UNITED STATES PATENT AND TRADEMARK OFFICE

APPLICATION NO.	FILING DATE	FIRST NAMED INVENTOR	ATTORNEY DOCKET NO.	CONFIRMATION NO.
10/740,017	12/18/2003	Michael Jackson II	706804US1	1703
24938	7590	12/12/2006	EXAMINER	
DAIMLERCHRYSLER INTELLECTUAL CAPITAL CORPORATION			FIGUEROA, ADRIANA	
CIMS 483-02-19			ART UNIT	
800 CHRYSLER DR EAST			PAPER NUMBER	
AUBURN HILLS, MI 48326-2757			3637

Office Action Summary

DETAILED ACTION

**FIG. 1**

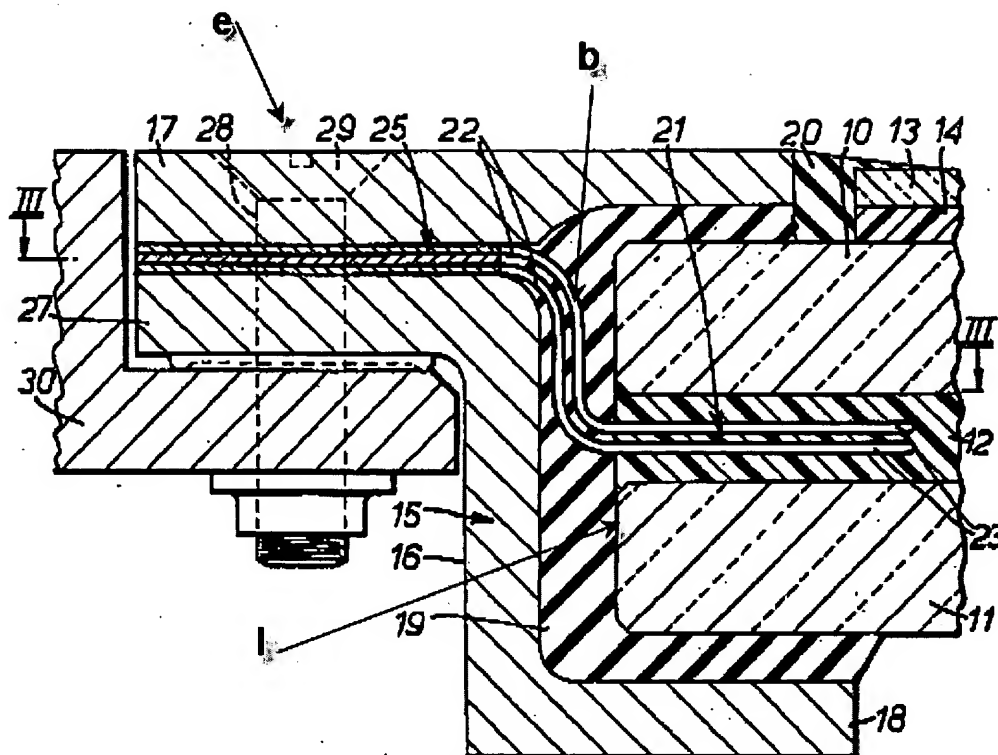
Regarding claim 1, Robert discloses a window assembly comprising: a first glass layer (10); a second glass layer (11) bonded to the first glass layer by an adhesive (12), the adhesive defining a spacing between the first and second glass layers; and an engagement module (e) having a portion adapted for bonding in the spacing between the first and second glass layers, (annotated Figure 1). The phrase "the engagement module adapted to connect the window to the window opening mechanism" is considered intended use and is given no patentable weight.

comprises a border (b) for bonding between the first (10) and second (11) glass layers and a central hub (16), (annotated Figure 1). The phrase "adapted to engage the window opening mechanism" is considered intended use and is given no patentable weight.

Regarding claim 7, Roberts discloses a window wherein the central hub (16) comprises an aperture (28), (annotated Figure 1). The phrase "for lockingly engaging the window opening mechanism" is considered intended use and is given no patentable weight.

Regarding claim 8, Roberts discloses a window wherein the engagement module (e) is bonded to a lower edge (l) of the window, (annotated Figure 1). The phrase "for vertical movement of the window by the window opening mechanism" is considered intended use and is given no patentable weight.

Regarding claim 6, Roberts discloses a window wherein the central hub (16) comprises an aperture (28), (annotated Figure 1). The phrase "for lockingly engaging the window opening mechanism" is considered intended use and is given no patentable weight.

Regarding claim 10, Roberts discloses a window wherein the engagement module (e) comprises a border (b) for bonding between the first (10) and second (11) glass layers and a central hub (16), (annotated Figure 1). The phrase "adapted to

Roberts (U.S. 3,953,630)

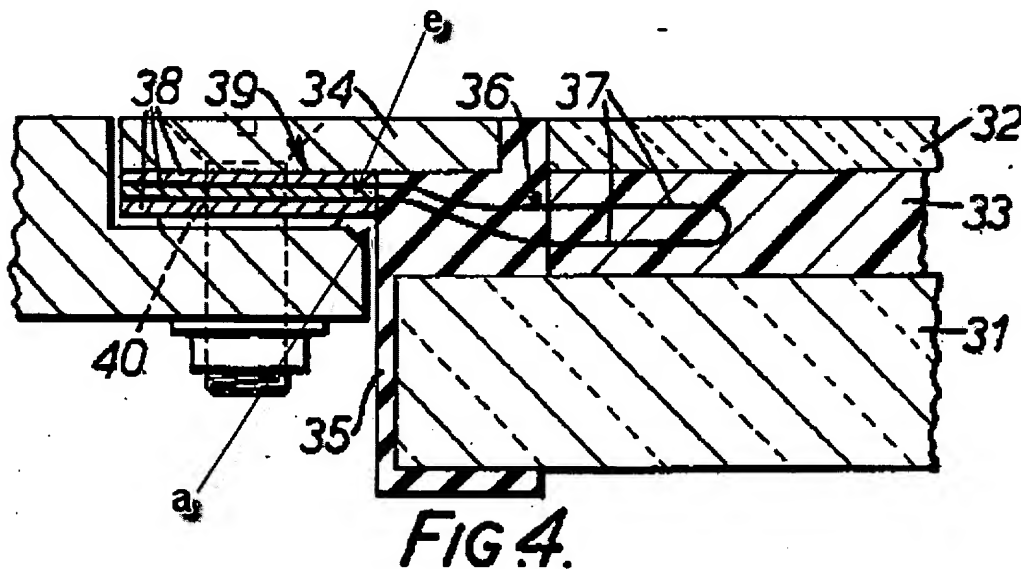
5. Claim 4 is rejected under 35 U.S.C. 103(a) as being unpatentable over Roberts (U.S. 3,953,630), Figure 1 in view of Roberts (U.S. 3,953,630), Figure 4. Roberts in Figure 1 discloses as discussed above but does not disclose an air gap between the

engagement module and the adhesive. However, Roberts in Figure 4 teaches an air gap between the engagement module and the adhesive (annotated Figure 4).

Therefore, it would have been obvious to a person having ordinary skill in the arts at the time of the applicant's invention to modify the window of Roberts in Figure 1 to have air gap between the engagement module and the adhesive as taught by Roberts in Figure 4 in order to make easier to mount the window or removed to be repaired.

8. Claim 17 is rejected under 35 U.S.C. 103(a) as being unpatentable over Roberts (U.S. 3,953,630), Figure 1 in view of Ohlenforst (U.S. 5,120,584) and further in view of Roberts (U.S. 3,953,630), Figure 4. Roberts in Figure 1 modified by Ohlenforst discloses as discussed above but does not disclose an air gap between the engagement module and the adhesive. However, Roberts in Figure 4 teaches an air gap between the engagement module and the adhesive (annotated Figure 4).

Therefore, it would have been obvious to a person having ordinary skill in the arts at the time of the applicant's invention to modify the window of Roberts in Figure 1 and Ohlenforst to have air gap between the engagement module and the adhesive as taught by Roberts in Figure 4 in order to make easier to mount the window or removed to be repaired.
